1 Products affected

2 Type of change

Product Change Notification					PCN - GS21 & GP21 - New Marking		
owner	creation date	release date	released by	change order no	rev	page	D10-039-861
bachmajo	23.09.2019	25.09.2019	limachcl	2018389	A	1 of 2

GS21 – Socket-Outlet	
Old product appearance	New product appearance
Old packaging label	New packaging label
Old product approval	New product approval
UL according to UL 2695	UL according to UL 2695 VDE according to IEC TS 62735-1

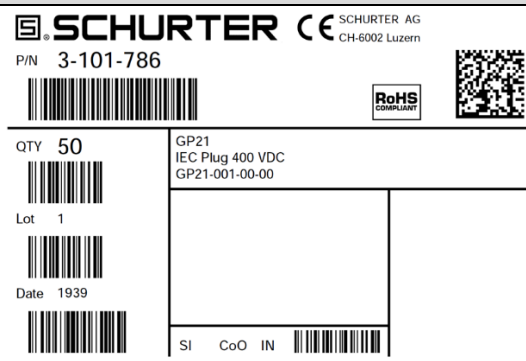
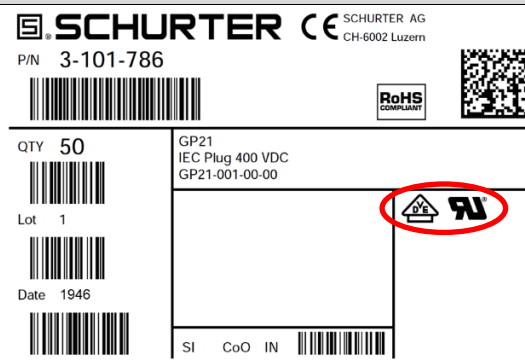
The socket-outlet GS21 and plug GP21 has achieved VDE approval according to IEC TS 62735-1.

Approval marks are added on the physical product as well as on the packaging label for both, socket-outlet and plug.
